NELSON CITY COUNCIL

Proposed Plan Change 18

Nelson South

**Planning Officers Report - Addressing Submissions
on the Plan Change prior to Hearing**

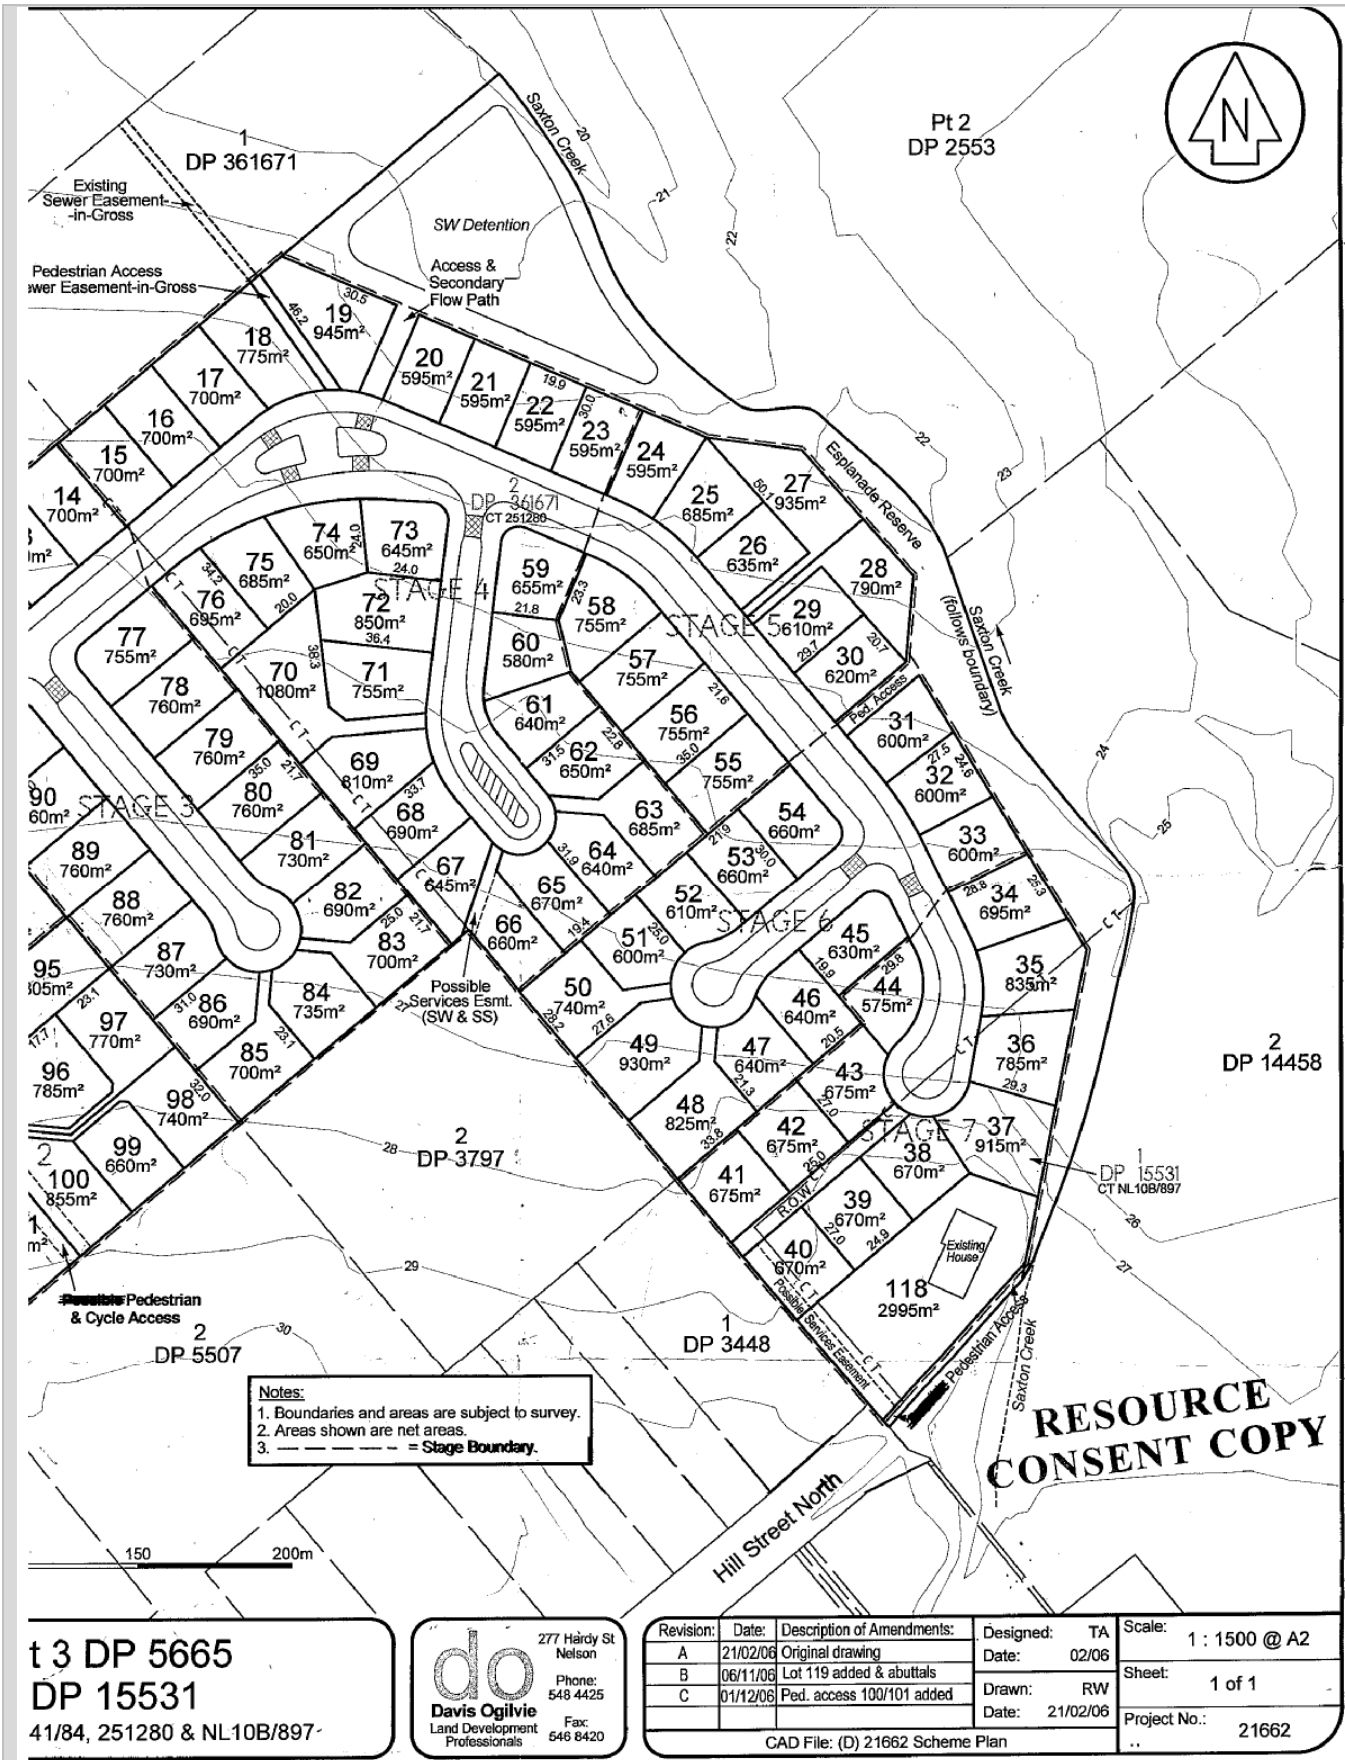
Submission 6.1 has requested alternative wording to the notified wording for the esplanade requirements adjoining Saxton Creek where previous subdivision approval has provided for a different esplanade reserve width. Submission 6.2 requested consequential changes to the Planning Maps to reflect this.

The Plan Change as notified proposed the following wording for the first bullet point of the Esplanade requirements for Saxton Creek:

- The conservation, access, hazard mitigation and recreation values of this esplanade reserve will be able to be realised with a 15 metre width
- It is consistent with the objectives and policies of the Regional Policy Statement, in particular policy DH1.3.3 relating to impacts on natural and conservation values associated with riparian margins (refer clause 5.43)

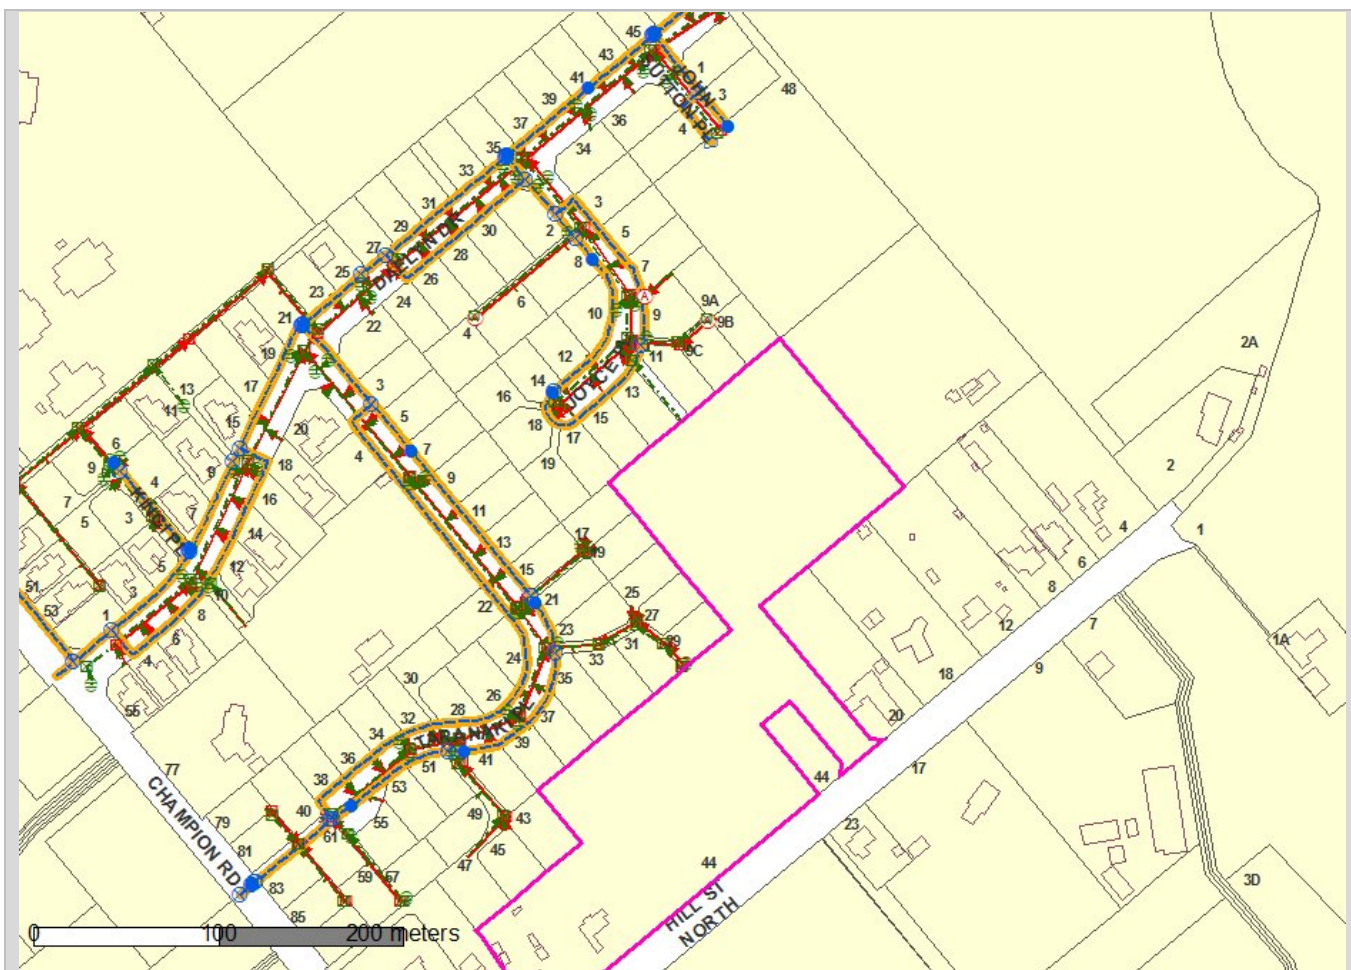
Paul S Winter – Submission point # 3.1

The map below shows the proximity of Council public stormwater and wastewater services to Mr Winter's land at 44 Hill Street. The stormwater infrastructure is shown as green, wastewater as red and water supply as blue. This map shows that if, Mr Winter proposed to subdivide in the future, connection to wastewater and stormwater could be provided into his site from existing services on the boundary between his property and 29 Taranaki Place. Stormwater connection could also be provided from the existing services located within the pedestrian walkway between 11 and 13 Joyce Place. In addition to the location of services the capacity of these services to meet the potential demand of any future subdivision would have to be considered. These matters would have to be considered at the time of subdivision. Any additional connection to services would have to be negotiated with adjacent landowners
